2.2.3 - Approved vs Proposed Ground Floor Elevation - Vine Lane (West)

2.2.4 - Approved vs Proposed Ground Floor Elevation - High Holborn (South)

3.1.1 - Approved vs Proposed Servicing Strategy Summary

5.1.1 - Museum Street Elevation (East) - Approved vs Proposed

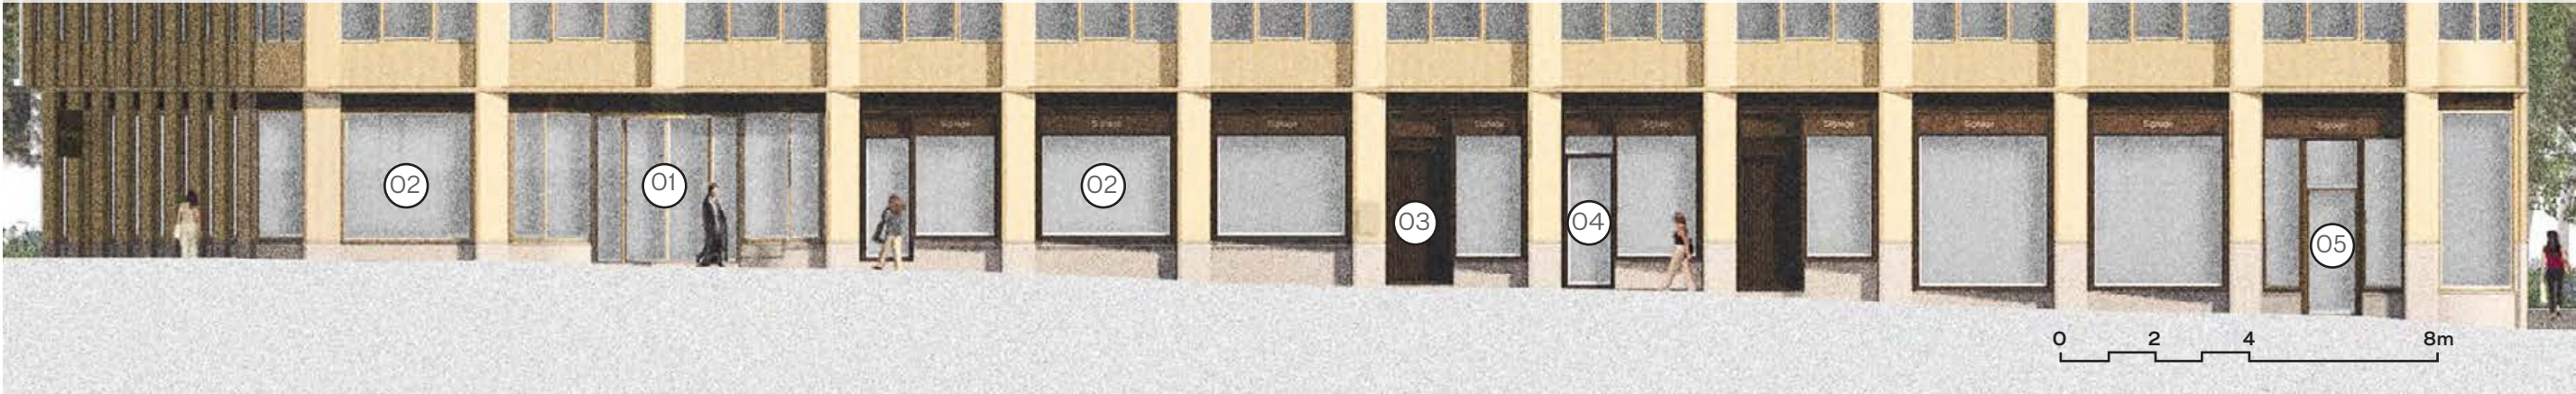
O1. The office lobby entrance has been shifted four bays to the north along Vine Lane - carefully integrated into the ground floor elevation with other entrances which contribute to activating the street.

O2. The Flexible Use Class E unit has been relocated to Vine Lane on either side of the office lobby entrance.

O4. The Vine Lane retail unit door has shifted four bays to the south along Vine Lane.

O3. The West Central Street fire escape exit door is now positioned on Vine Lane, and the existing fire escape door has moved one bay to the south.

O5. The south-west retail unit entrance has shifted one bay further to the South along Vine Lane to improve visibility from High Holborn and draw in the retail parade.

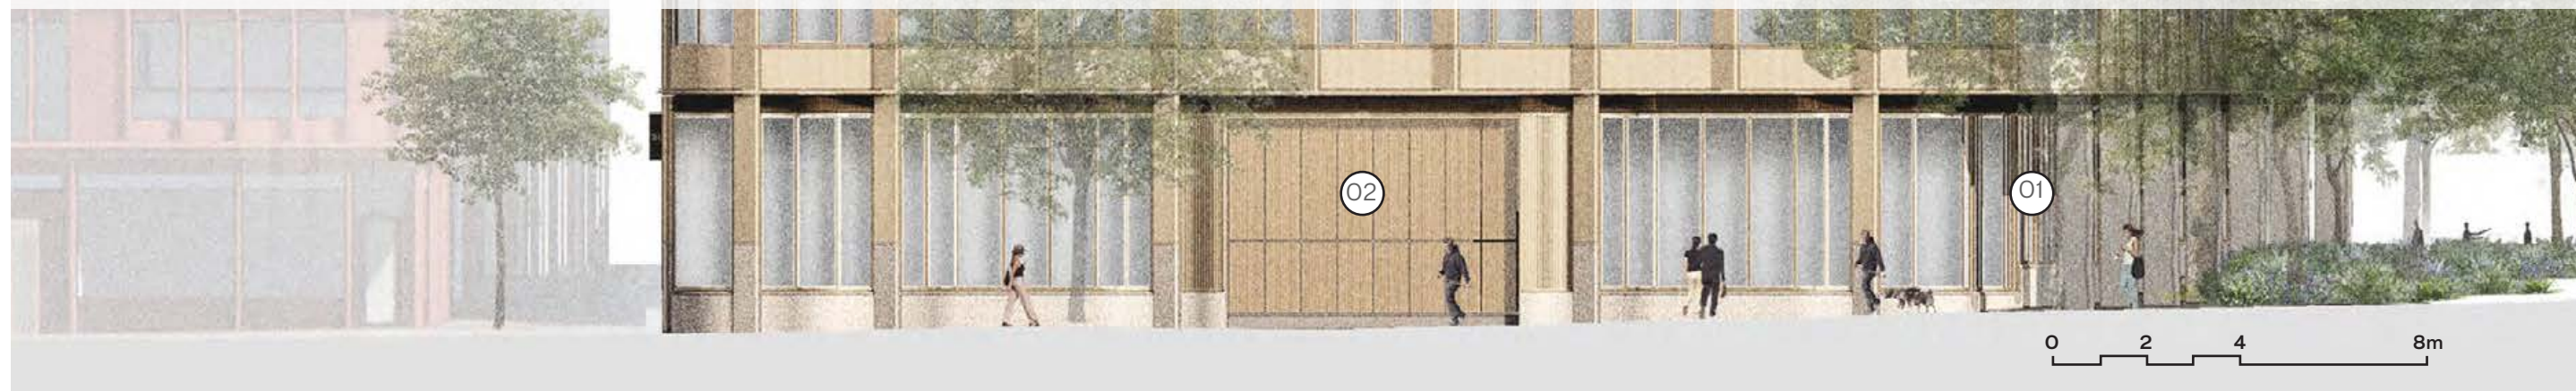
O1. Entrance door to south-east retail unit now sits along the Museum Street colonnade - opening out onto the generous public realm landscape.

O2. The loading bay entrance has shifted east and is now centrally located on the High Holborn elevation - providing visual balance to the facade, along with a more efficient servicing strategy for the building, and more generous retail spaces either side.

2.3.1 - External Views Comparison - Museum Street Office Entrance

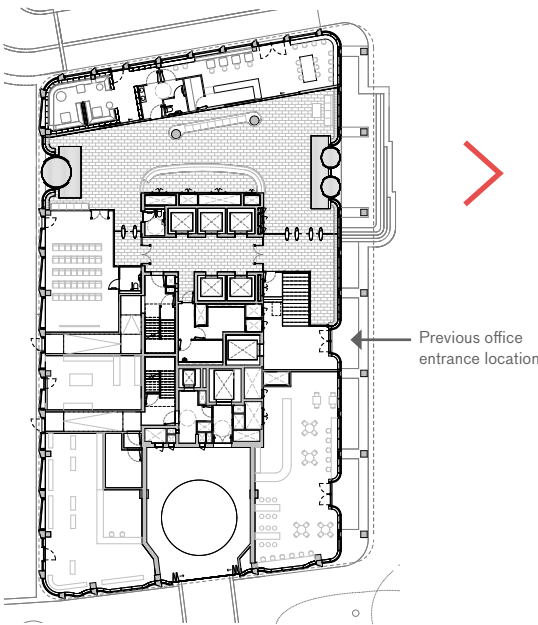
O1. The proposed Museum Street main office entrance location has shifted two bays north, to the position shown in the right hand view below. In the approved scheme, this particular bay was a shopfront into the flexible use space - see also comparative ground floor elevations on pg.10 for reference.

2.3.2 - External Views Comparison - Museum Street Cyclist Entrance

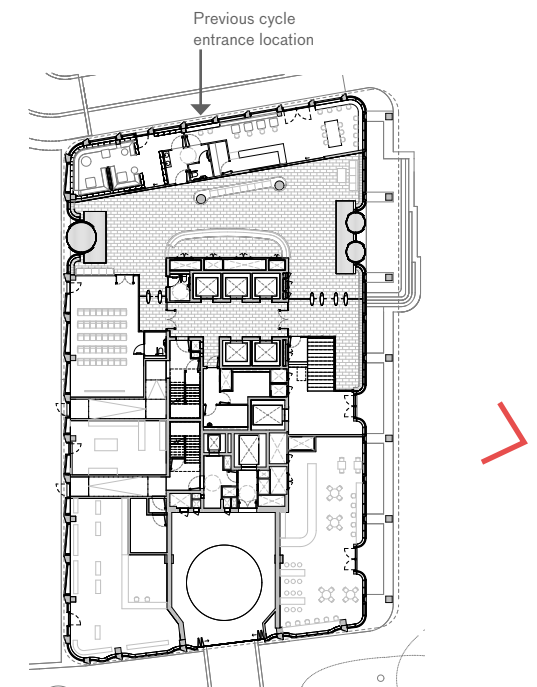
O1. The proposed Museum Street main office entrance location has shifted two bays north, to the position shown in the right hand view below. See also comparative ground floor elevations on pg.10 for reference.

O2. The proposed office cycle entrance has moved to Museum street colonnade from West Central Street, into the position where the office lobby entrance was, offering improved prominence and access to basement end of trip facilities.

2.3.3 - External Views Comparison - Museum Street Retail Entrance

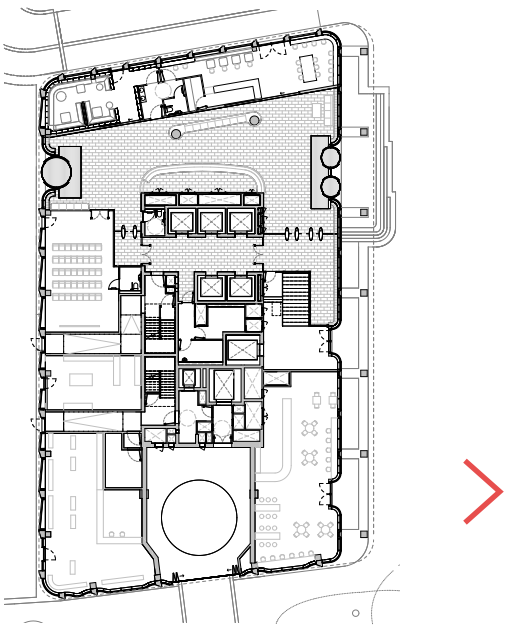
O1. The South-East retail unit entrance has moved to the Museum Street colonnade opening out onto the generous public realm. The position close to High Holborn ensures visibility to arrivals from the east.

Note - dual entrances are not possible in this unit without introducing an internal level change.

2.3.4 - External Views Comparison - High Holborn Retail Entrance

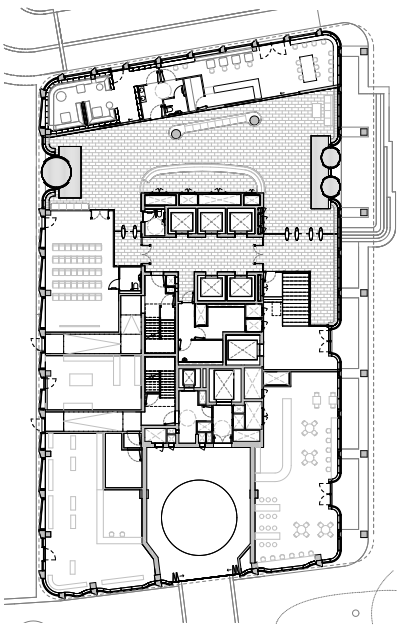
- O1. The South-East retail unit entrance has moved to the Museum Street colonnade.

O2. The Loading bay entrance has shifted east and is now centrally located along the High Holborn elevation.
- O3. Relocation of cycle hire docking stations - refer to Section 3.0 - Servicing Strategy for further details.

O4. Proposed new tree on High Holborn repositioned to west of loading bay entrance.

2.3.5 - External Views Comparison - Vine Lane Retail Entrance

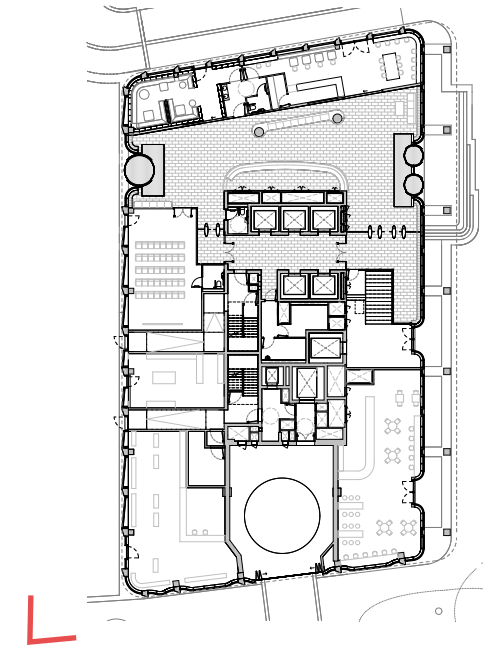
O1. The South-West retail unit entrance has shifted one bay south along Vine Lane, which will help activate the Vine Lane - High Holborn corner improving visibility from the west and drawing visitors into Vine Lane.

2.3.6 - External Views Comparison - Vine Lane Office Entrance

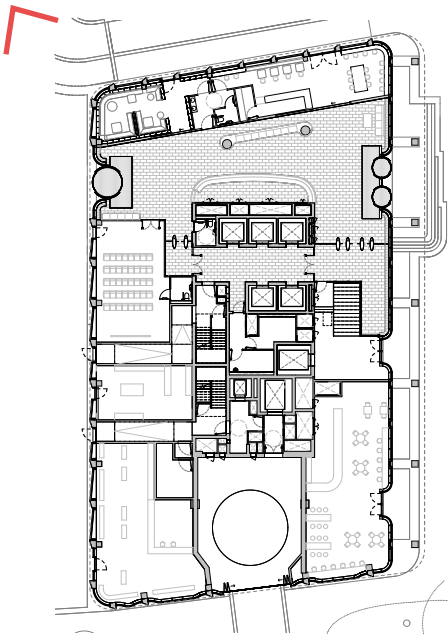
- O1. The office lobby entrance on Vine Lane has been shifted 4 no. bays to the north along Vine Lane.
- O2. The Flexible Use Class E unit has been relocated to Vine Lane on either side of the office lobby entrance.

- O3. The Vine Lane retail unit door has shifted 4 no. bays to the south.

2.3.7 - External Views Comparison - West Central Street Retail Entrance

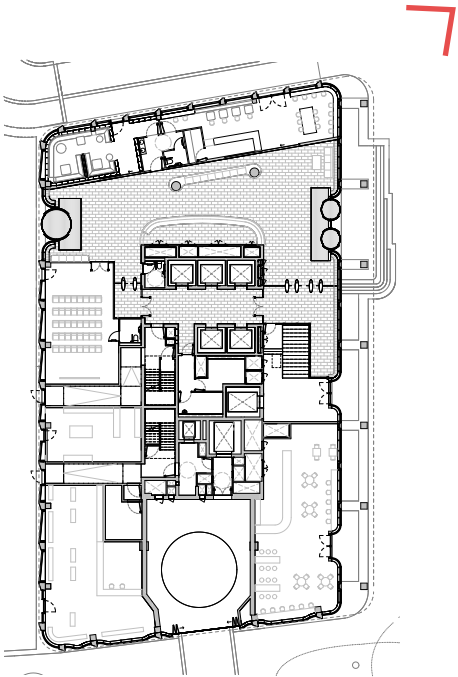
- O1. The North-West retail unit has been relocated to the North-East corner of the building. Double entrance doors on West Central Street elevation serve this unit.
- O2. The proposed office cycle entrance has moved to Museum street colonnade from West Central Street, into the position where the office lobby entrance was.
- O3. The fire escape door from West Central Street elevation has been relocated to Vine Lane.

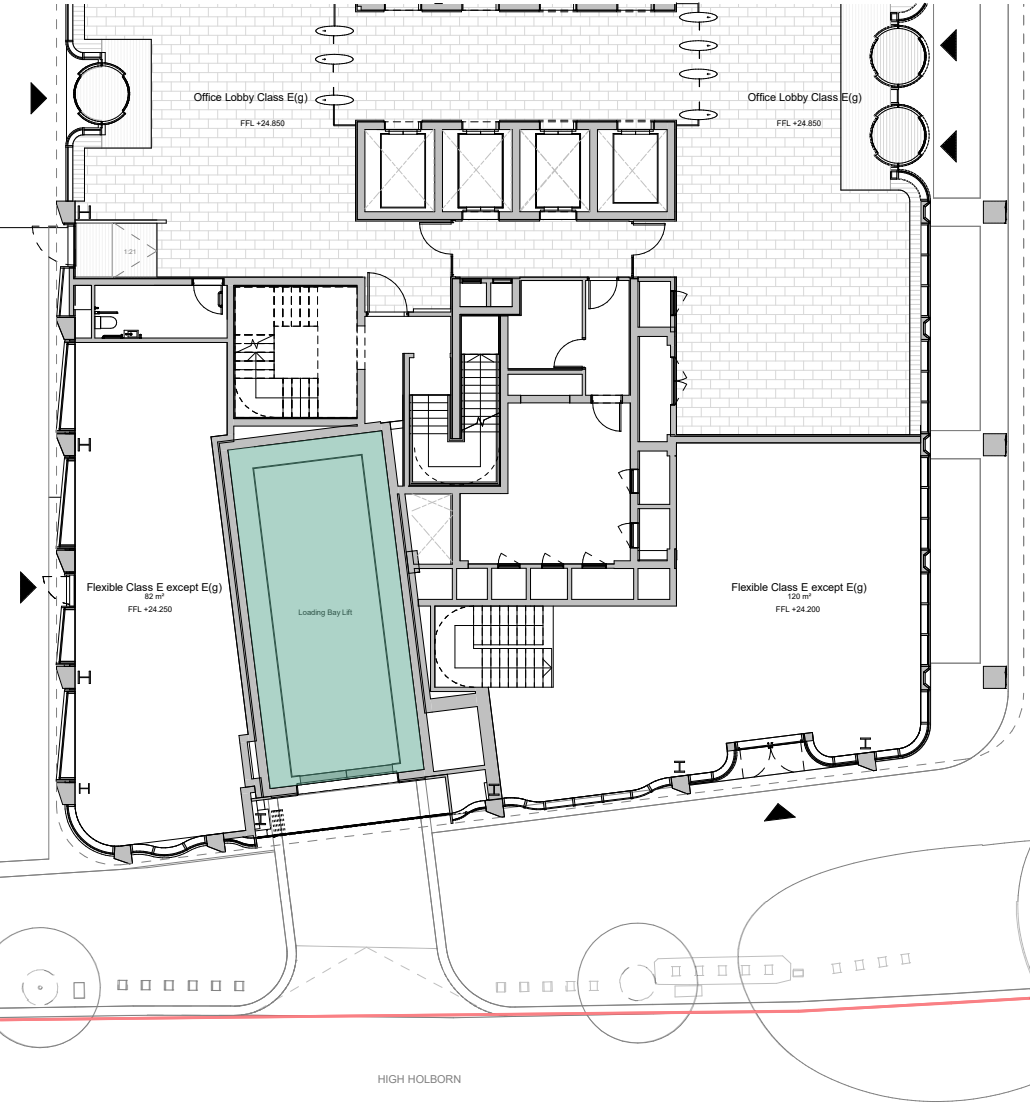
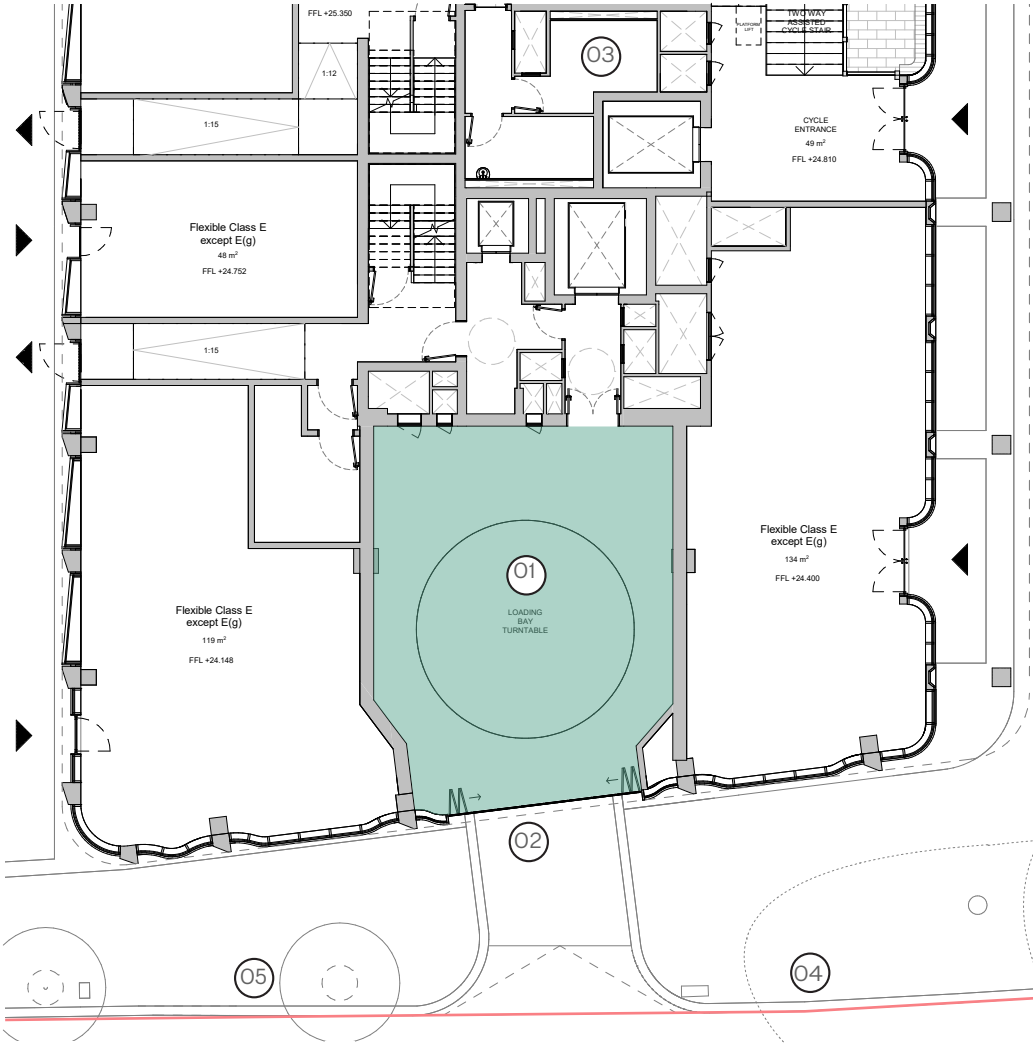
- 01. Vehicular lift replaced with a turn-table.
- 02. The Loading bay entrance has shifted East and is now centrally located along the High Holborn elevation.
- 03. The core layout has been refined.
- 04. The relocation of Santander Cycle Hire Docking Stations will be captured under a seperate planning application (see note below).
- 05. Proposed new tree on High Holborn repositioned to the west side of the loading bay entrance.

The planning permission for the Museum Street scheme includes a minor relocation of part of the existing Santander Cycle Hire Docking Station on High Holborn. This was proposed to facilitate access to the vehicle lift to transport delivery vehicles to and from the basement. This minor relocation was agreed in principle following discussions with the Council and Transport for London and would be subject to a separate planning application.

The proposed at-grade service yard associated with the Section 73 application will require the cycle hire docking station to be provided in a different location. In parallel, demolition and construction logistics plans have been further explored, and are likely to impact the placement and operation of the Santander bikes in this location.

As such, there will be a requirement to relocate the cycle hire docking station during the demolition and construction phases. As the demolition and construction phases are likely to be longer than 18 months, the applicant has explored alternative locations where the cycle hire docking station could be permanently sited in another location to retain a consistent level of service close by. Discussions are ongoing between the applicant team, the Council and Transport for London. A separate planning application will be submitted by Transport for London (TfL) to the Council to relocate the station to a nearby location. Therefore, the proposed drawings for the amended Ground Floor layout omit reference to the existing cycle hire docking station.

4.1.1 - Basement Level 1 Layout Summary

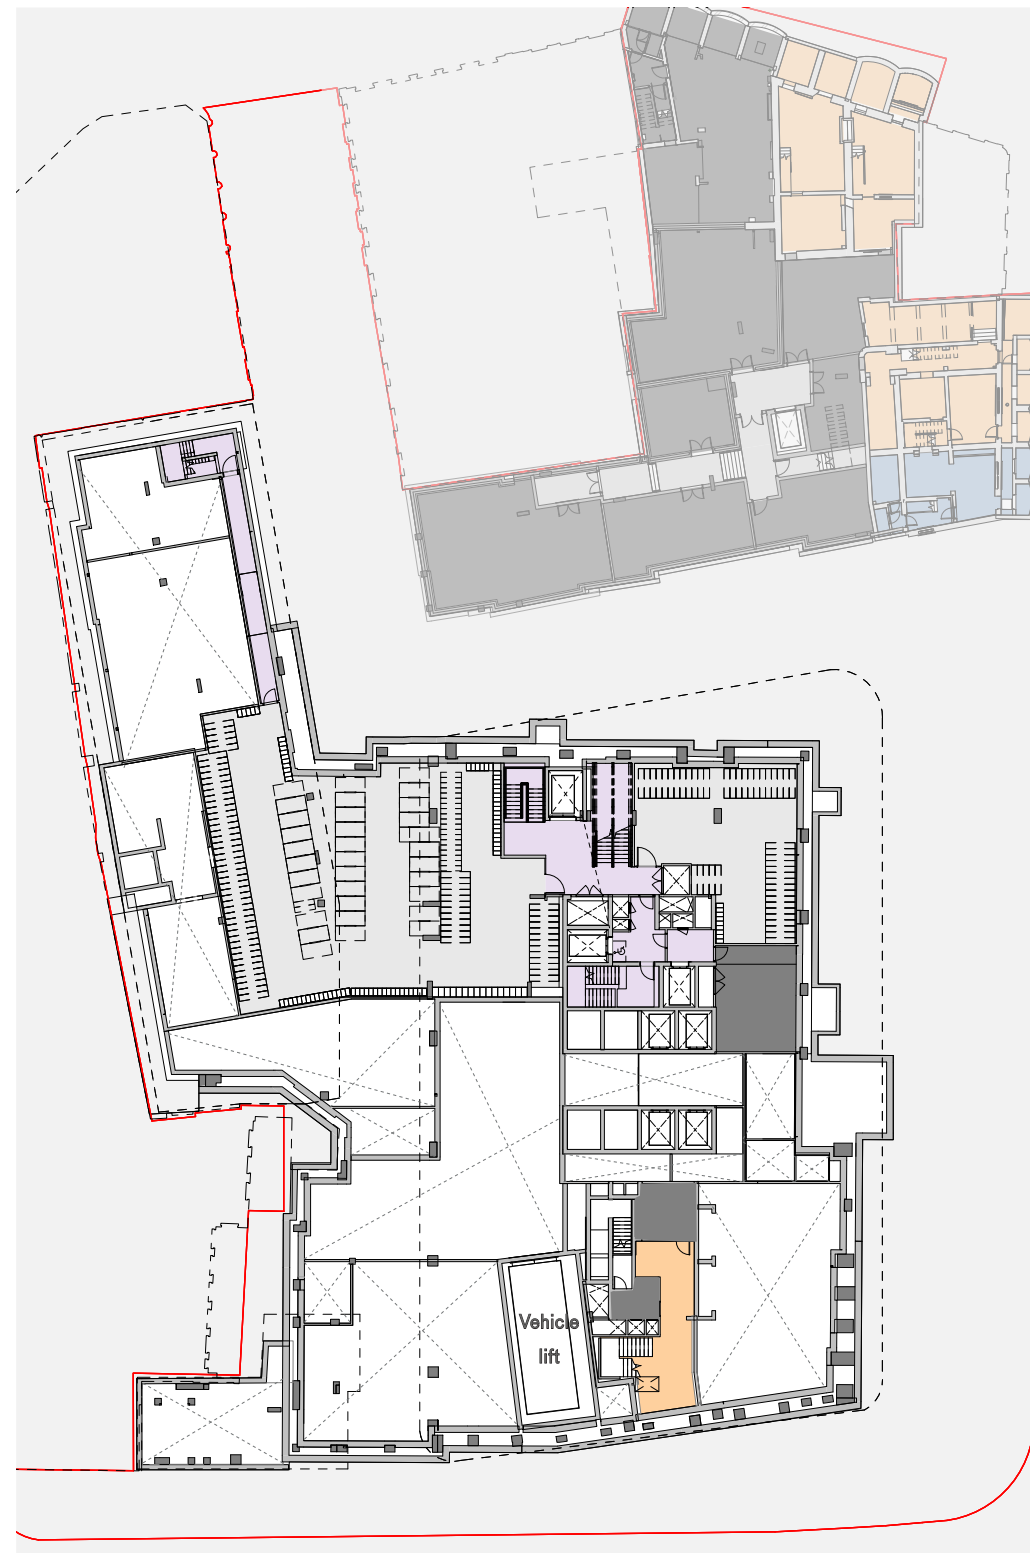
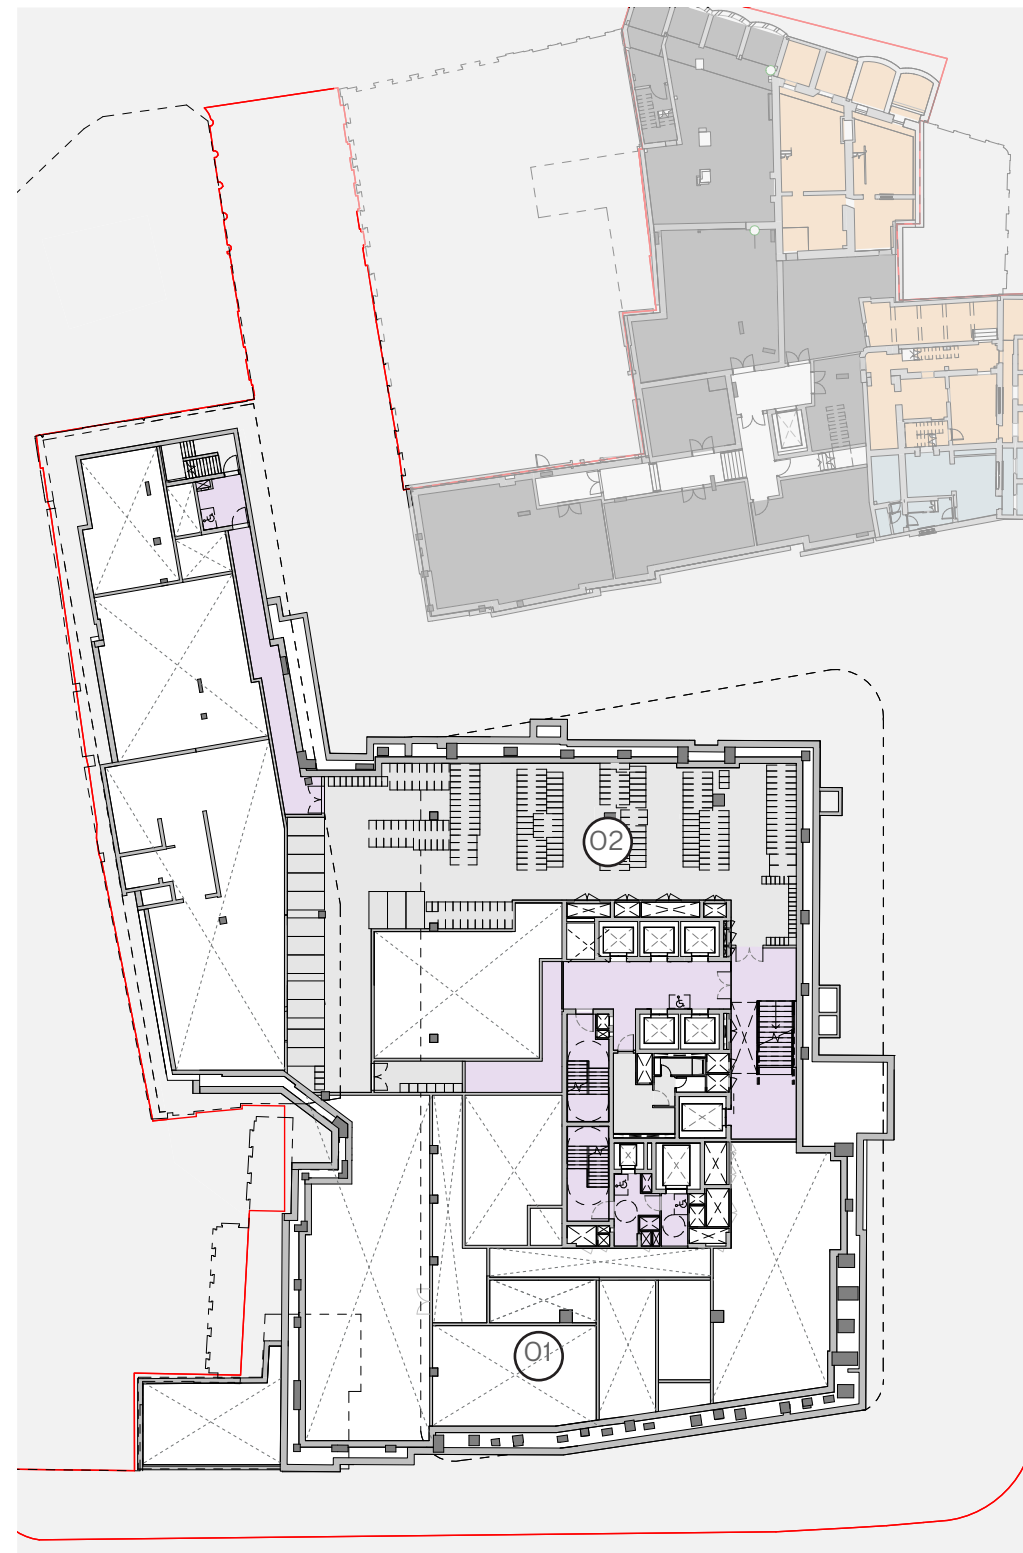
O1. The loading bay and vehicular lift have been removed at both basement levels - as part of the development of a more efficient servicing strategy for the building.

O2. Minor adjustments to the long stay cycle parking and shower facilities, capacity is in line with updated area schedule and compliant with London Plan requirements.
